HISTORIC DISTRICT REVIEW BOARD REGULAR MEETING AGENDA

Agenda Item: APPLICATION FOR AN ALTERATION, HDRB #25-007, to consider an application for a Certificate of Appropriateness for an alteration to add an entry portico to the single-family residential building located at 706 Main Drive, Herndon, Virginia.

Subject: APPLICATION FOR AN ALTERATION, HDRB #25-007, to consider an application for a Certificate of Appropriateness for an alteration to add an entry portico to the single-family residential building located at 706 Main Drive, Herndon, Virginia

Resolution- to approve a Certificate of Appropriateness to permit an alteration to add an entry portico to the single-family residential building located at 706 Main Drive, Herndon, Virginia, located in the southeast corner of the intersection of Main Drive and Vine Street, and further identified as Fairfax County Tax Map 0162 04 0030B.

SCALE:	As indicated
SHEET TITLE:	Right Elevation
SHEET NUMBER:	A2.2

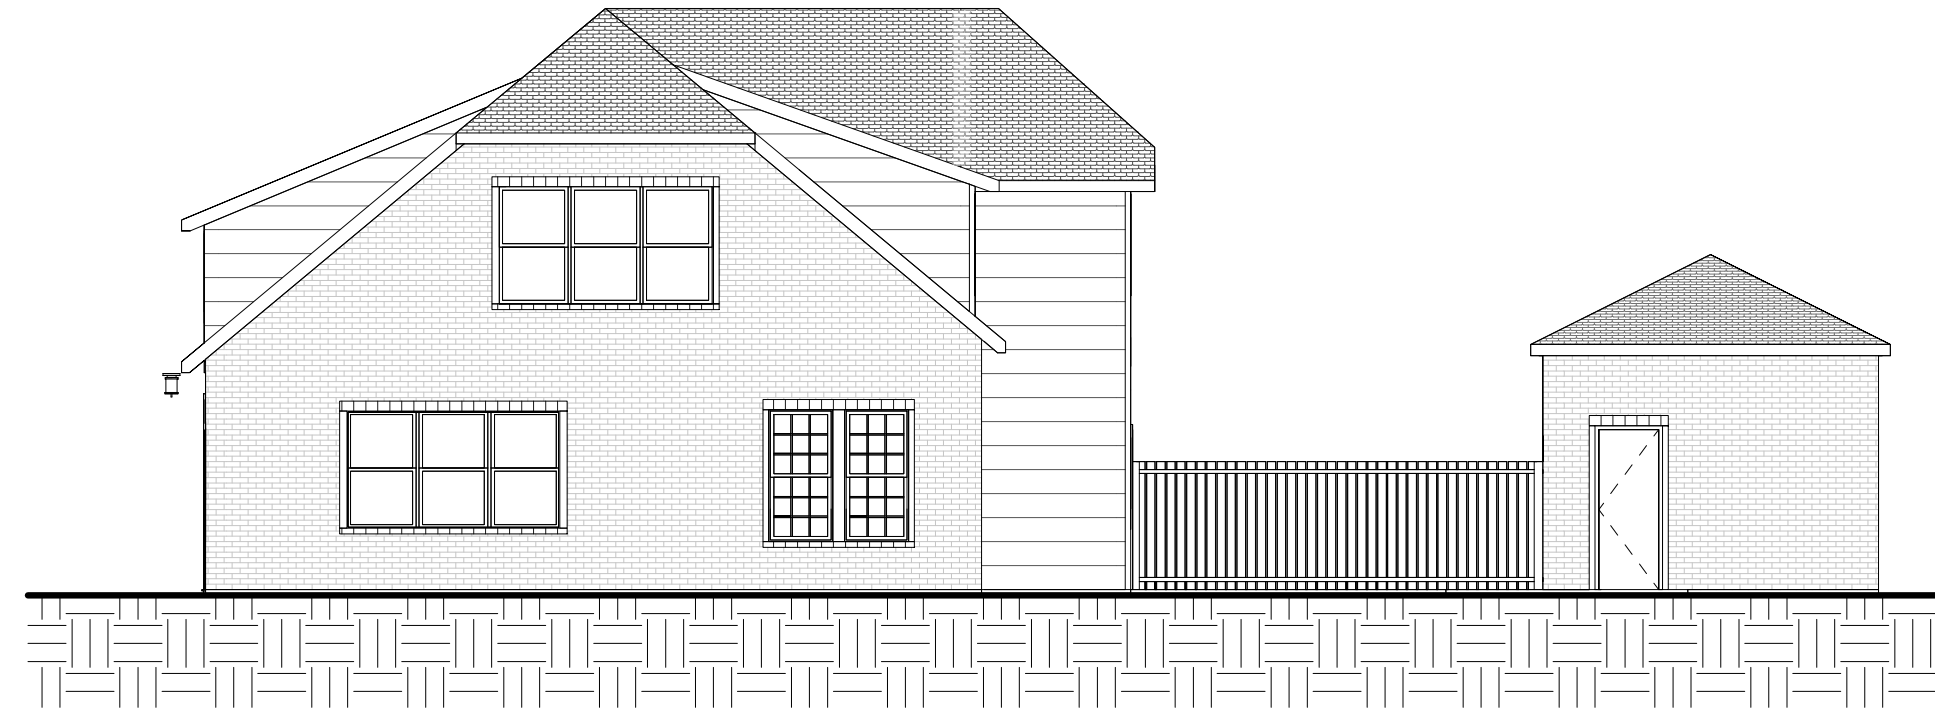
Note: Painting the yellow brick cladding of the dwelling and garage are not included in the scope of work for HDR25-007. Additionally, the applicant has changed the proposed roofing material to flat seam metal (see drawing A2.3).

- d. This approval does not include painting the yellow brick cladding of the dwelling or the garage.
 - e. The applicant shall coordinate with town staff prior to installation of the portico to provide in-process documentation to add to the case record demonstrating that the modification will be reversible and confirming that any necessary penetrations into the mortar joints are properly sealed.

SCALE:	As indicated
SHEET TITLE:	Front Elevation
SHEET NUMBER:	A2.3

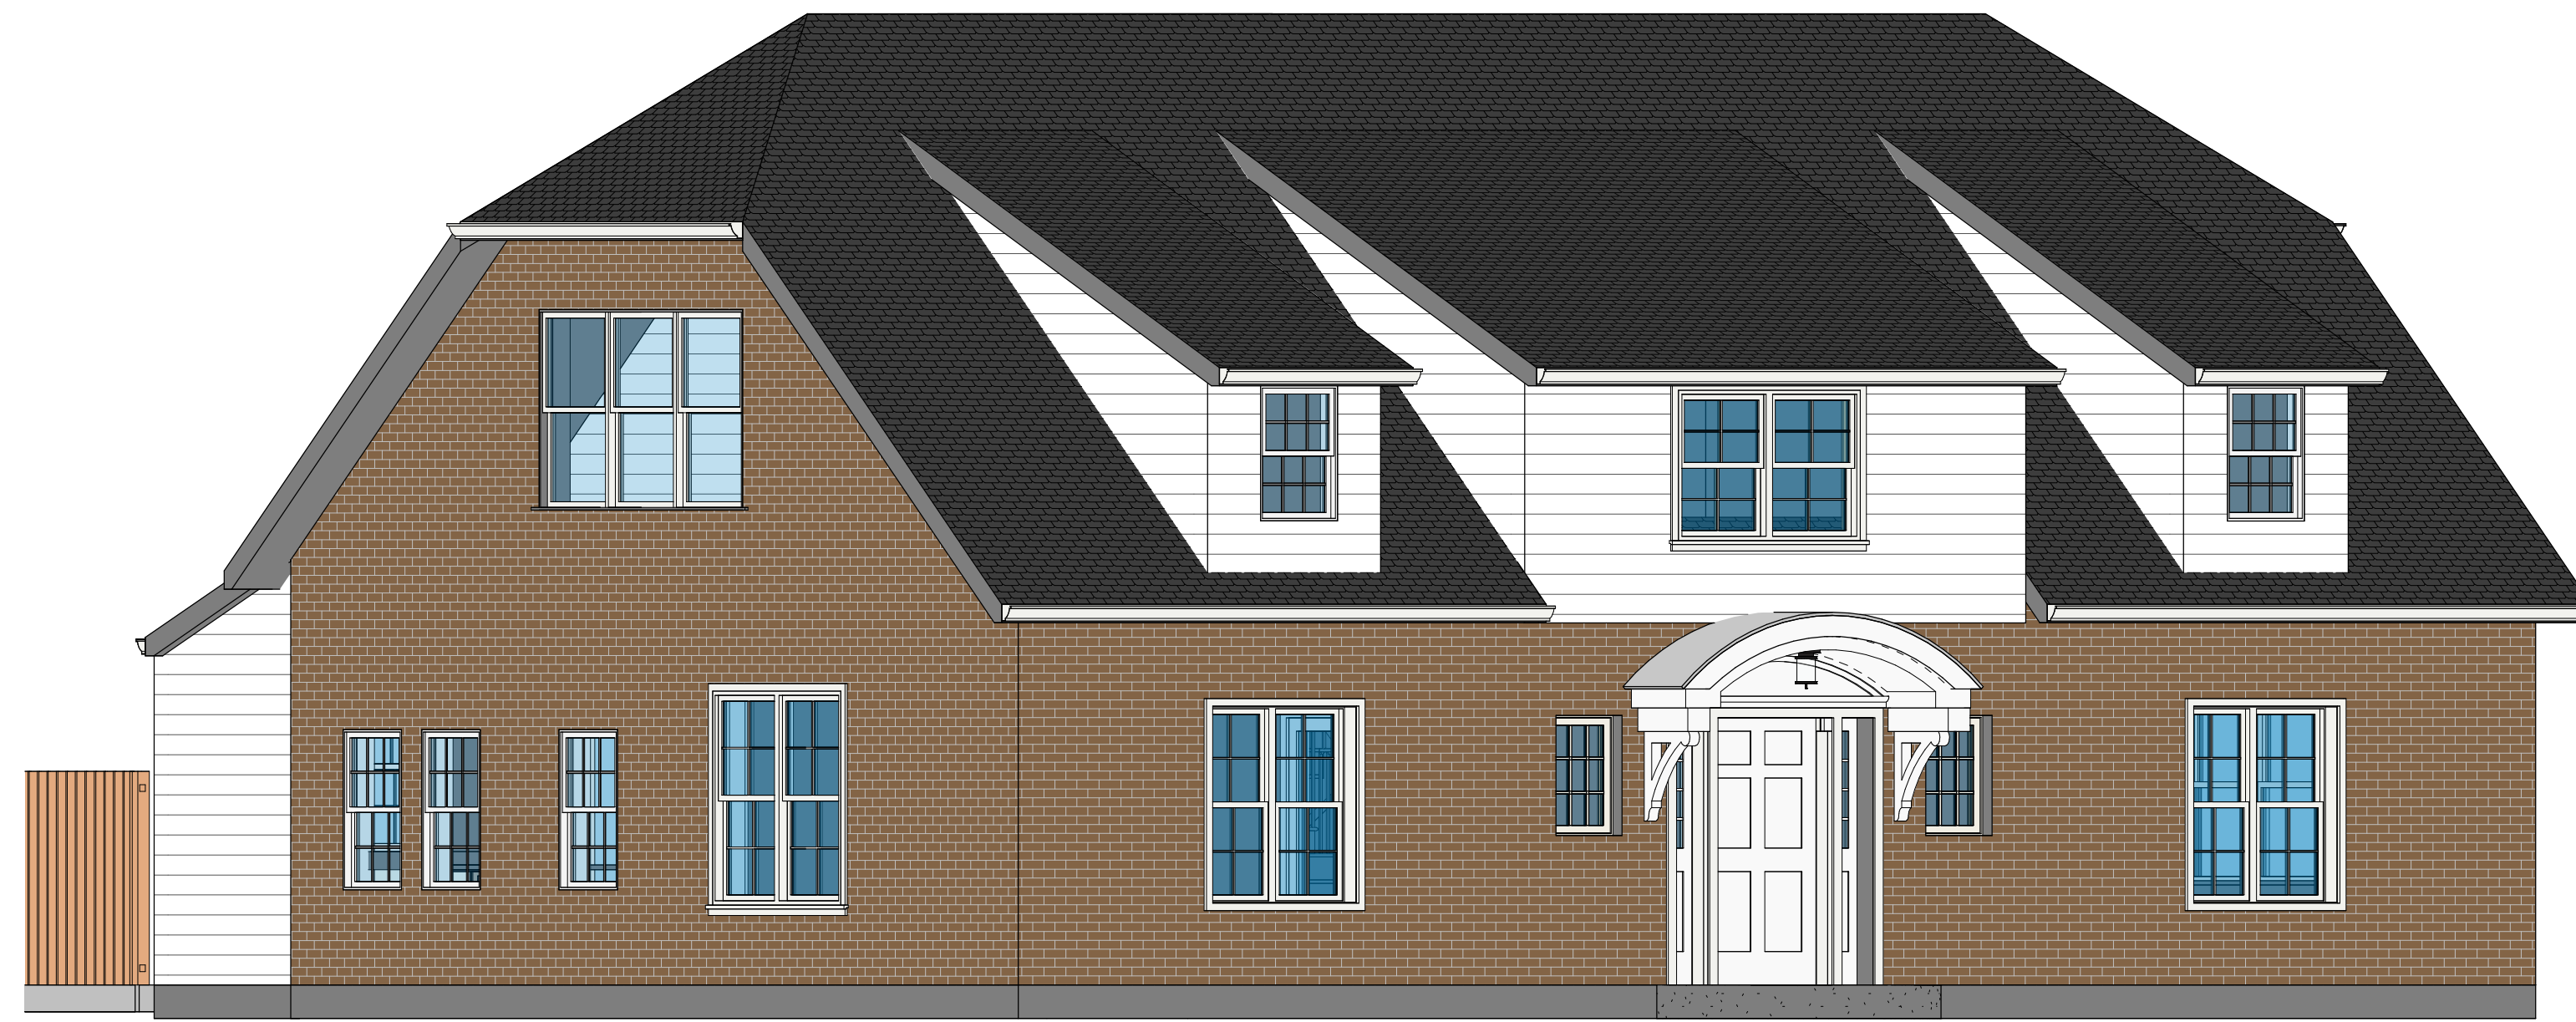
- The updated design still features brackets used to support the roof of the portico, rather than columns.
- Revised drawing sheet A2.3 and new sheet A4.2 depict the brackets as thinner than the initial design reviewed during the August 6 work session.
- The proposed roofing type is flat seam metal.
- “Tapcon” or equivalent expansion masonry screws will be used to affix the portico and inserted only into the mortar.

Staff have prepared a draft resolution that includes conditions for the reversible installation of the portico without damage to character-defining features, the proper sealing of necessary penetrations in the mortar, flat seam metal roofing, and in-process documentation demonstrating that the portico will not damage character-defining features to be added to the case file. The conditioned draft also specifies that the Certificate of Appropriateness does not include approval for painting the yellow brick cladding of the dwelling or garage.
